SERVICE BULLETIN NO: 32-018

MODIFICATION NO: ECN 04-0333

LANDING GEAR - MAIN LANDING GEAR SPECIAL BOLT ASSEMBLY - INSPECTION AND REPLACEMENT

Special Bolt - Inspection
Figure 1

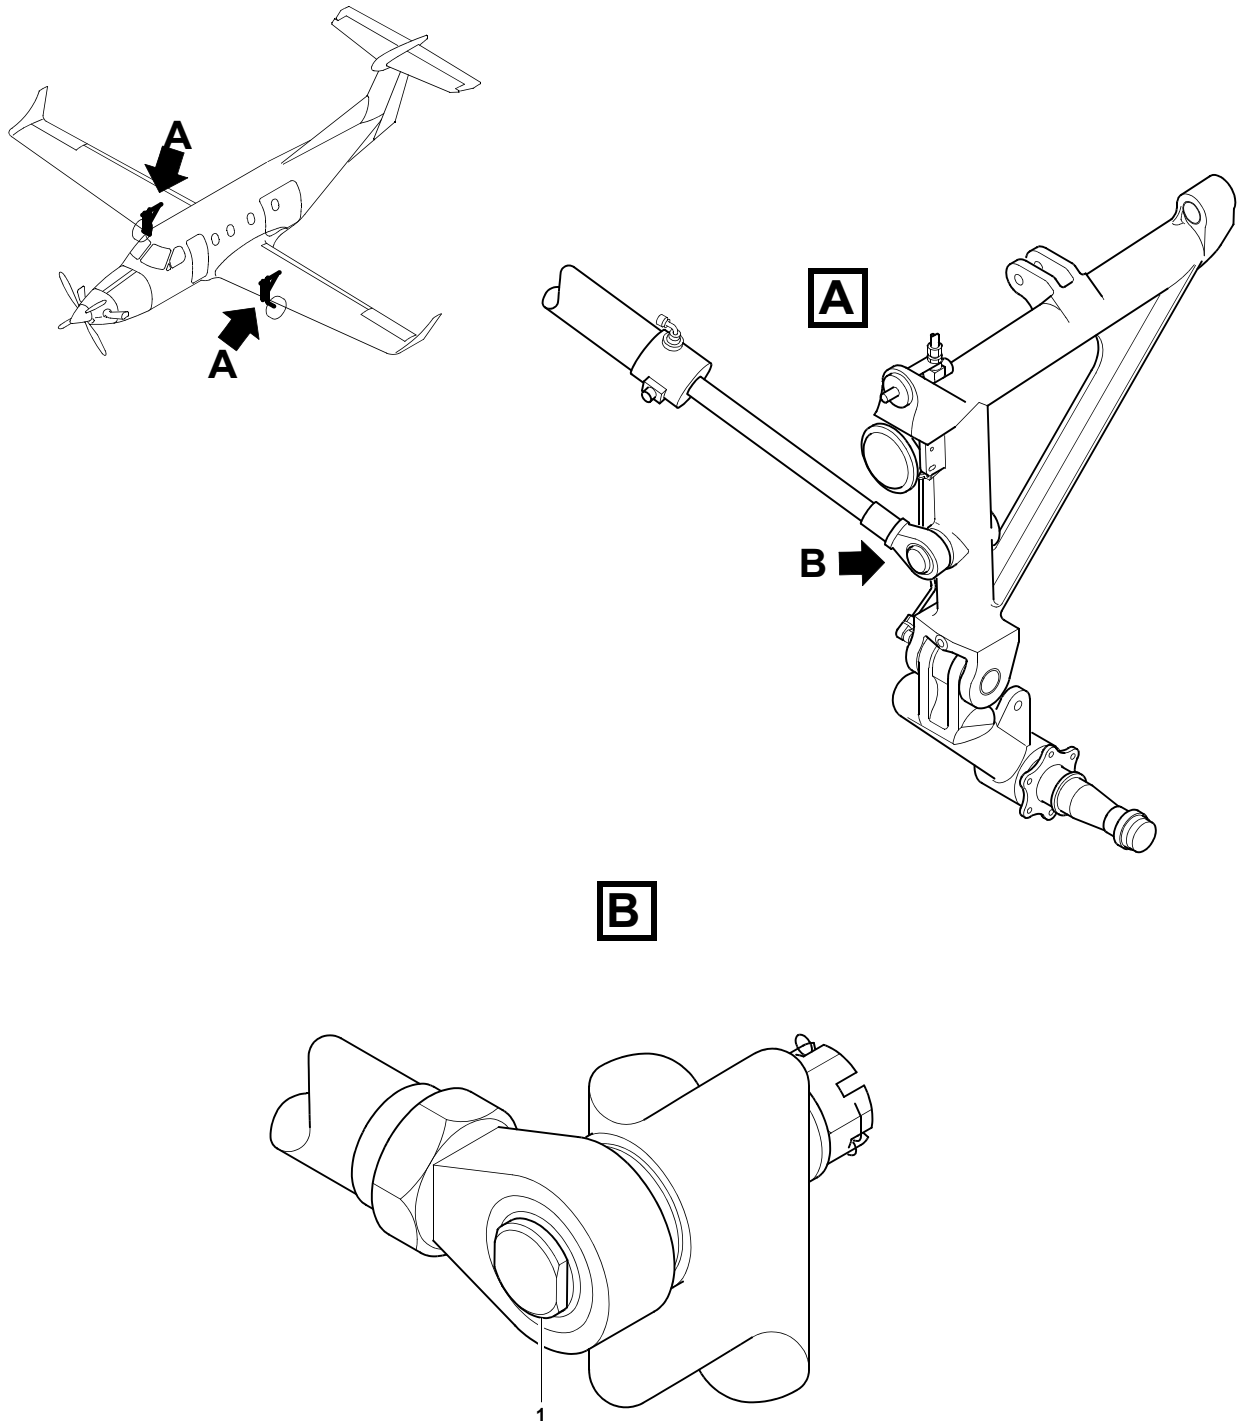
A. Inspection (Ref. Fig. 1)

- (1) Do an inspection of the left and right MLG assemblies to find bolts (1) that do not have white primed and painted heads.
- (2) Replace all bolts that do not have white primed and painted heads (Ref. Part D). Send removed bolts to PILATUS

Special Bolt - Replacement
Figure 2

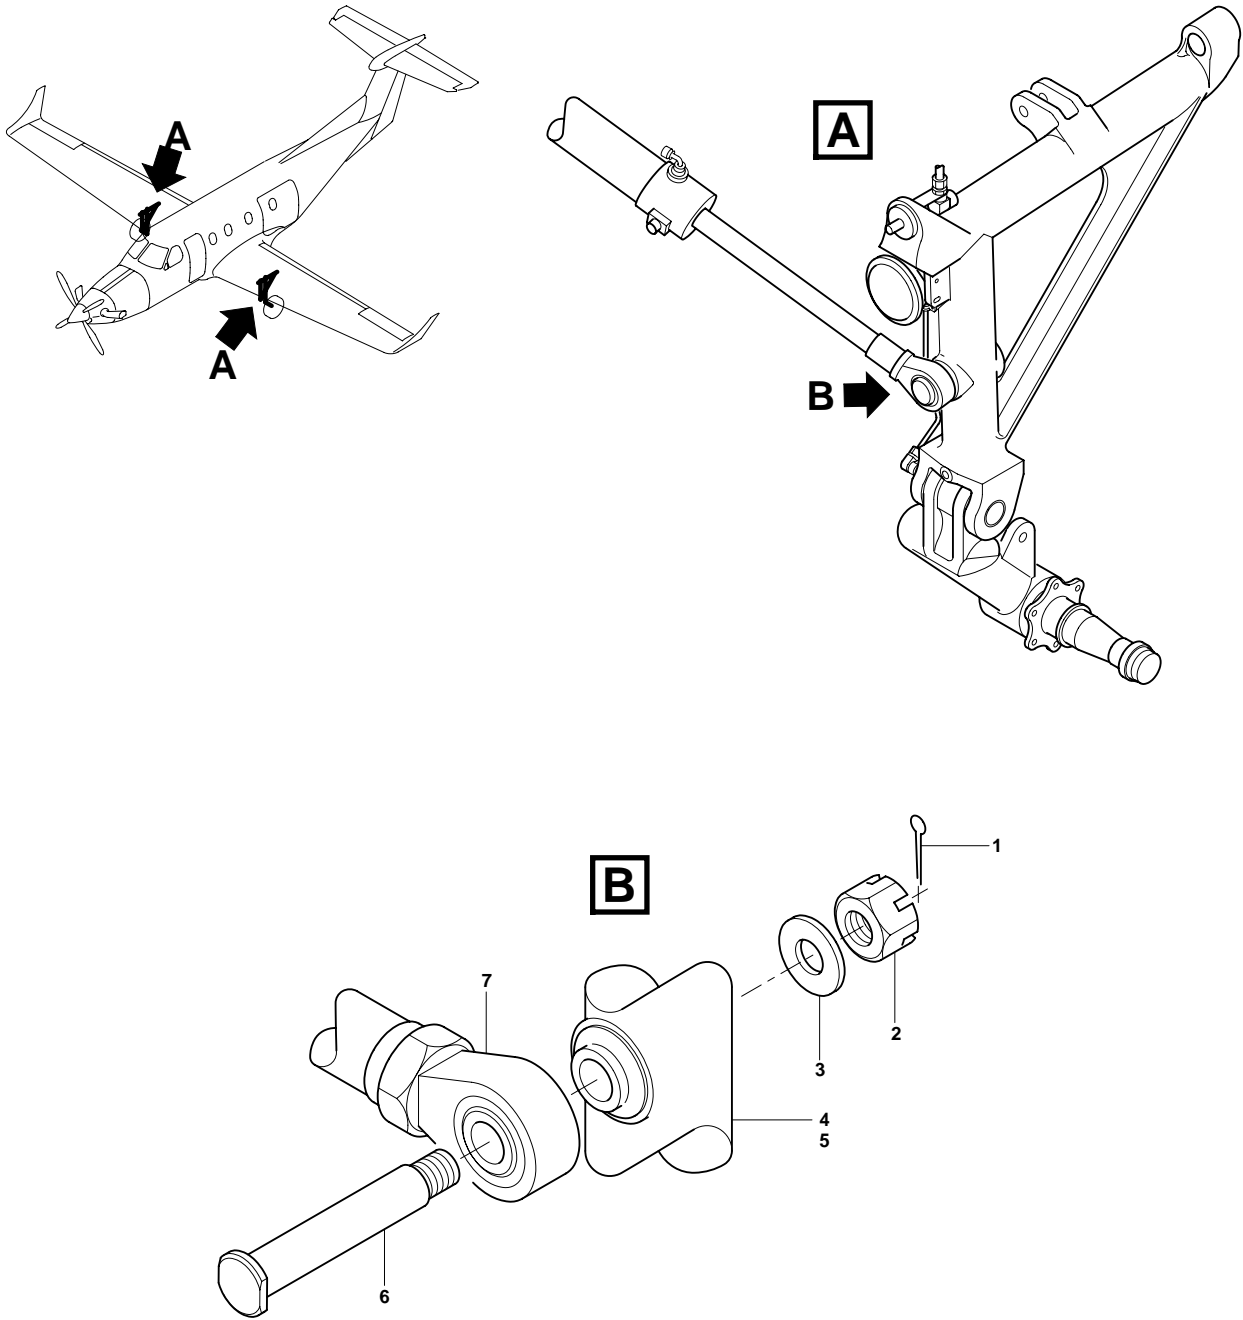
- (1) Remove the cotter pin (1), nut (2), washer (3) and bolt (6) to disconnect the actuator (7) from the left MLG assembly (4). Discard the cotter pin and washer. Send the bolt to PILATUS.
- (2) Obey the manufacturers instructions and use the solvent (Material Item No. P01-008 or approved alternative) to clean the bolt holes in the MLG assembly (4) and eye end of the actuator (7).

- (3) Obey the manufacturers instructions and apply layers of the corrosion preventative (Material Item No. P04-012) on the faying surfaces of the new bolt (6), eye end of the actuator (7) and MLG assembly (4).

- (4) Align the eye end of the actuator (7) with the bolt hole in the MLG assembly (4). Put the new bolt (6) in position.
- (5) Put the new washer (3) on the bolt (6) and install the nut (2).

- (6) Torque the nut (2) to between 1800 and 2000 lbf in. (200 and 220 Nm). (Ref. AMM, 20-20-01, Page Block 1).
- (7) Obey the manufacturers instructions and use the solvent (Material Item No. P01-008 or approved alternative) to remove the unwanted corrosion preventative.

- (8) Install the new cotter pin (1) (Ref. AMM, 20-20-00, Page Block 1).
- (9) Do Steps (1) thru (8) again to replace the bolt (6) in the right MLG assembly (5).
